DEVIATION REQUEST AND DECISION FORM

Project Name :	Silverado Ranch, Filing 2
Schedule No.(s) :	3516000001
Legal Description :	N2 SEC 16-15-63 EX TH PT PLATTED TO SILVERADO RANCH FILING NO 1

Deviation Exhibit

Exhibit 1
Length of Cul-de-Sac
Silverado Ranch Filing No. 2 (LSC#S224530)

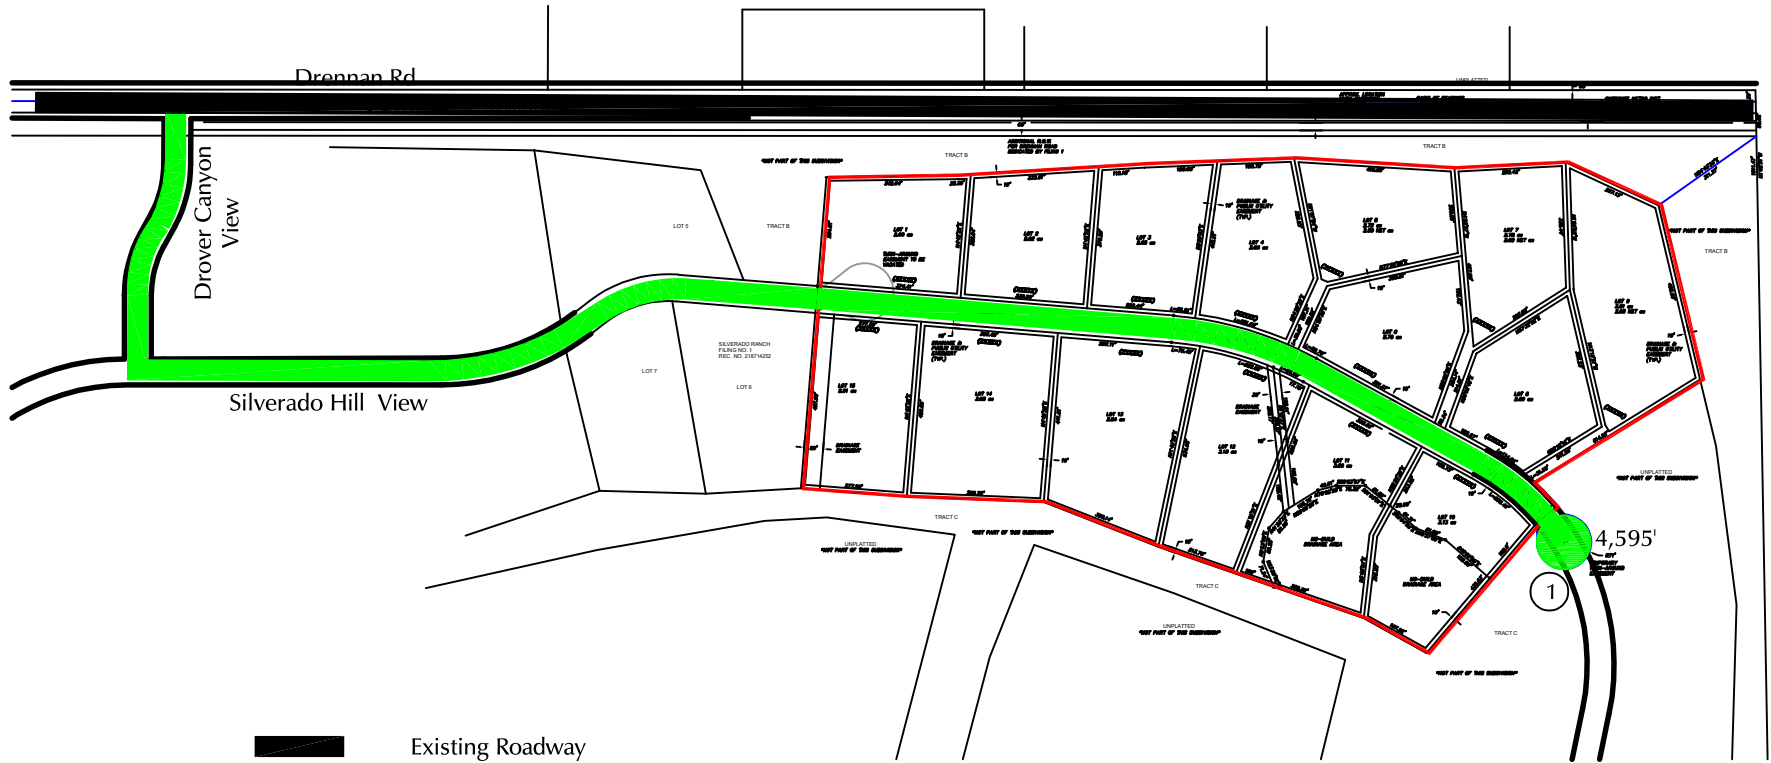
A temporary cul-de-sacs is proposed, so it should be 2.3.8.C. The maximum length for the temporary cul-de-sacs is 600ft. Please revise. Also, please indicate which type of temporary cul-de-sacs for this project (Within the Plat, Outside the Plat of a Phased Development or on Property not Owned by the Current Developer).

Silverado Hill Loop. Update throughout document
